Generic Environmental Impact Statement for License Renewal of Nuclear Plants

Supplement 38

Regarding Indian Point Nuclear Generating Unit Nos. 2 and 3

Draft Report for Comment

2
3 **Figure 4-3. Percentage of entrainment composed of RIS fish and total identified fish**
4 **relative to the estimated total entrainment at IP2 and IP3 combined**
5 **(data from Entergy 2007b)**
6

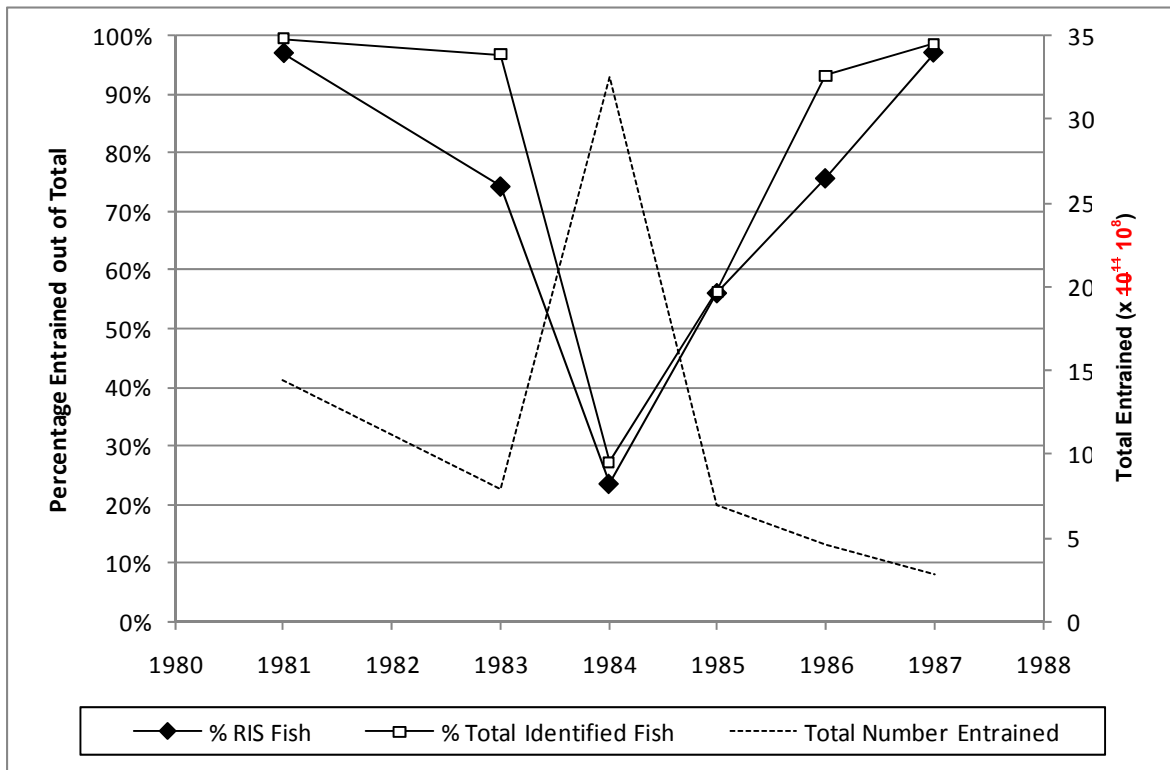
In the FSEIS, the NRC staff estimated the number entrained for a given week as the product of the mean density entrained and the combined weekly flow for IP2 and IP3. The error in the entrainment catch density directly affects Figure 4-3 in Section 4.1.2, and the error is repeated in Figure H-5 in Appendix H. In these figures, the total number entrained on the right axis should be in units of numbers $\times 10^8$ instead of numbers $\times 10^{11}$. The corrected Figures 4-3 and H-5 appear below. In addition, these changes affect two portions of text in the FSEIS.

1 **Figure 4-3 on page 4-15 in the FSEIS is corrected as follows:**

3
 4 **Figure H-5. Percentage of entrainment composed of RIS fish and total identified fish**
 5 **relative to the estimated total entrainment at IP2 and IP3 combined**
 6 **(data from Entergy 2007b)**

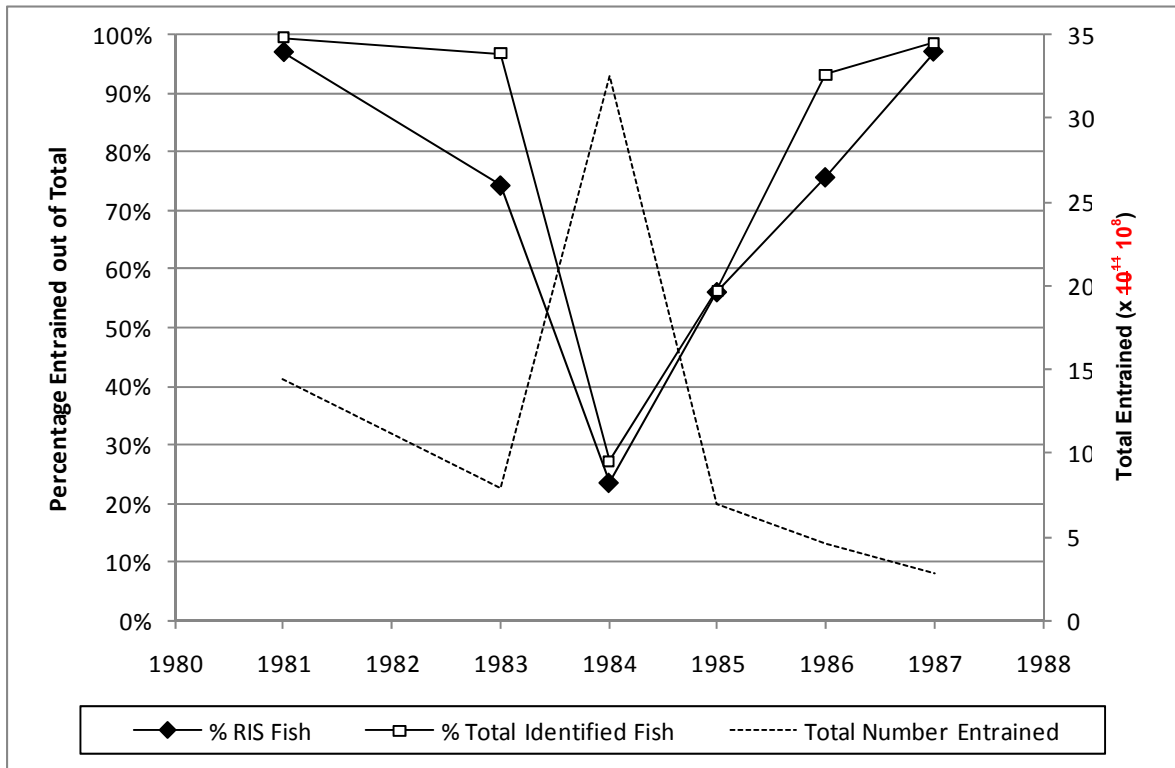
1 **Figure H-5 on page H-23** in the FSEIS is identical to Figure 4-3 in the FSEIS and is corrected
 2 as follows:
